STAFF RECOMMENDATION

2804 Oakland Avenue

May 19, 2021

Application: New Construction—Addition and Outbuilding (DADU); Setback Determination

Figure 2. Exterior stair and door in gable field to be removed.

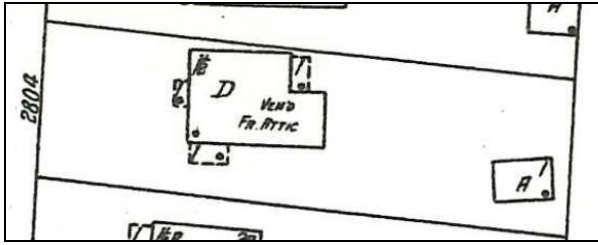
Partial Demolition: The plan includes the demolition of an existing upper-level door and exterior stairs on the right-side façade (Figure 2). The 1957 Sanborn map indicates that the house was a single-family home at the time (Figure 3). Since the door and exterior stairs were added after 1957, staff finds removal of these elements to be appropriate and to meet the design guidelines. No other changes are proposed to the historic house.

Staff finds the partial demolition to meet Section V.2 for appropriate demolition and to not meet Section V.1 for inappropriate demolition.

SITE PLAN

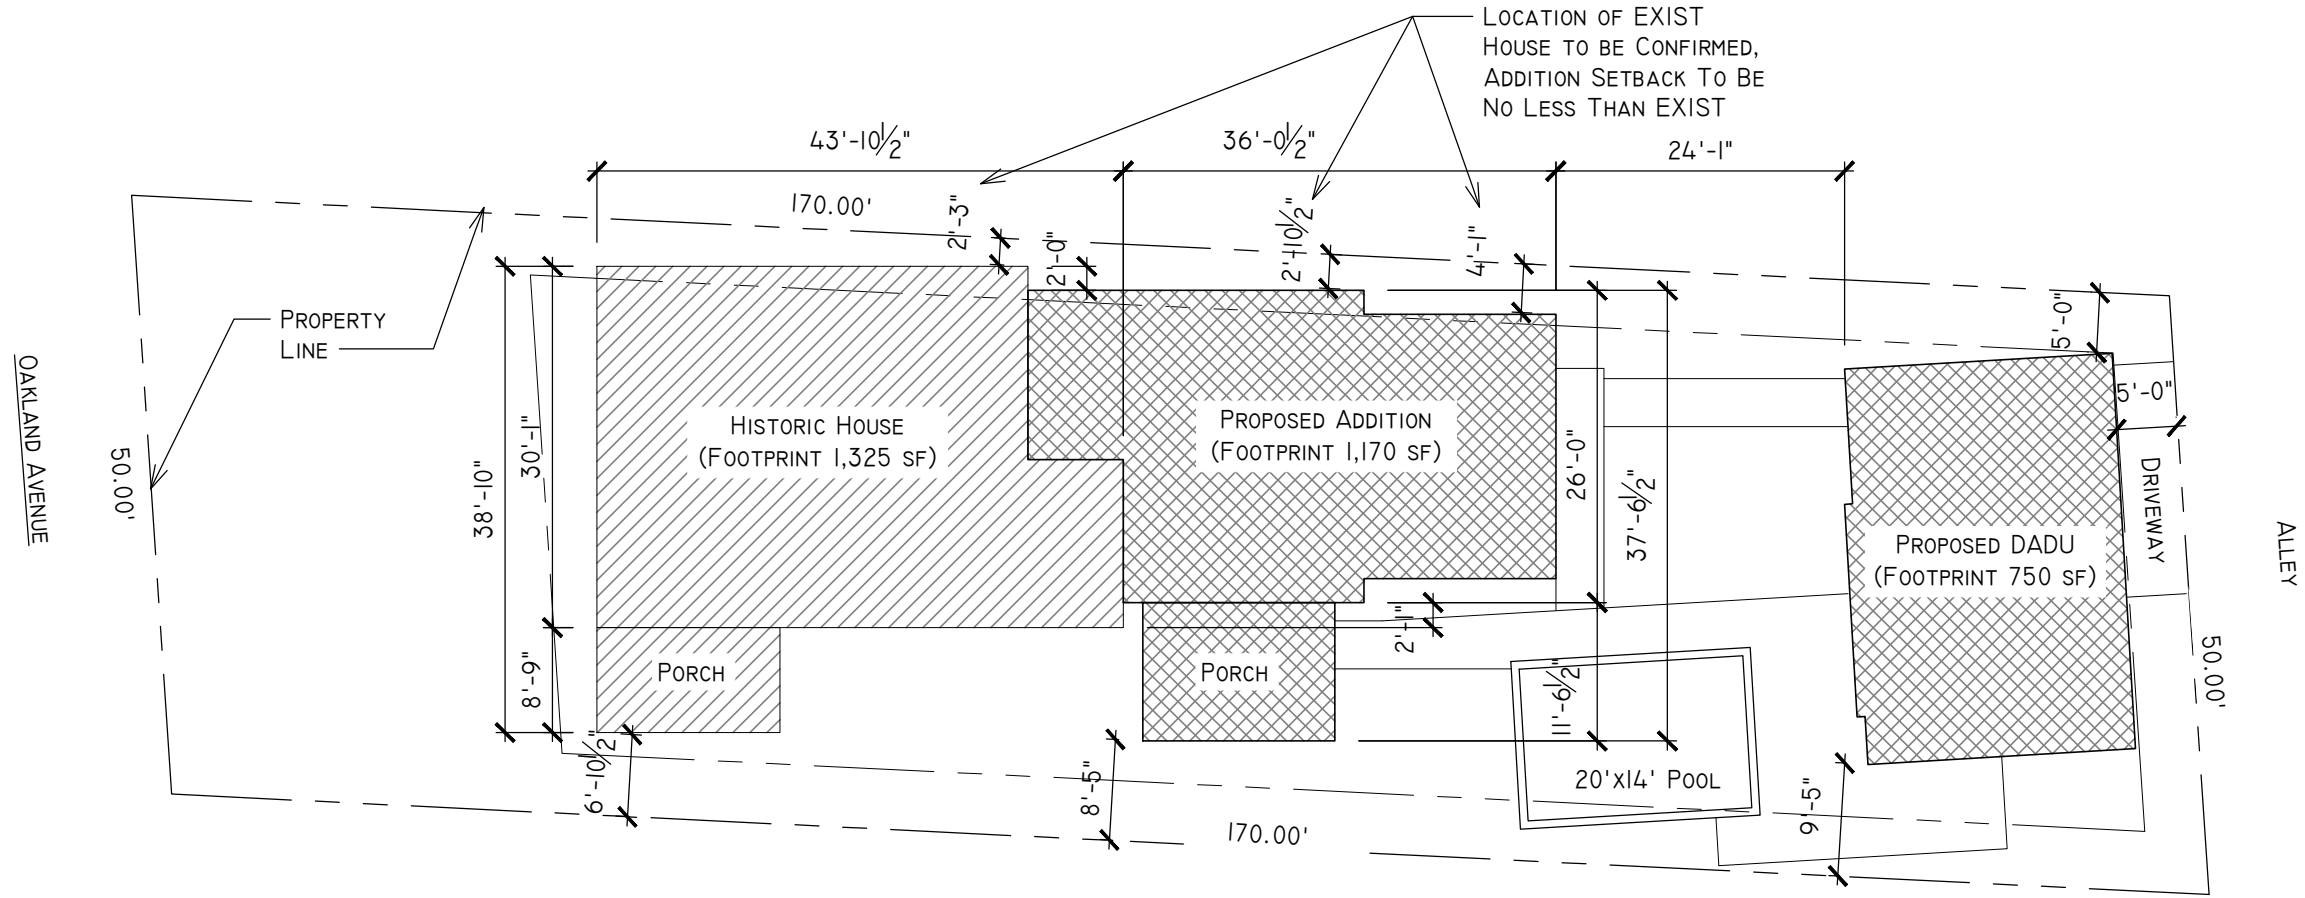
Setback & Rhythm of Spacing: The proposed addition meets the bulk zoning standards for the right-side and rear setbacks. The new construction is located eight feet, ten inches (5'-10") from the right-side property line and approximately fifty feet (50') from the rear property line. The applicant requests a setback determination to reduce the left-side setback from five feet (5') to two feet, ten (2'-10"). In this case, the lot is somewhat askew, and the house is not parallel to the lot lines. The historic house is located approximately two feet, one inch (2'-1") from the left-side property line. Since the addition sets in two feet (2') for the full depth and is no closer to the property line than the historic house, staff finds that the setback determination can be appropriate.
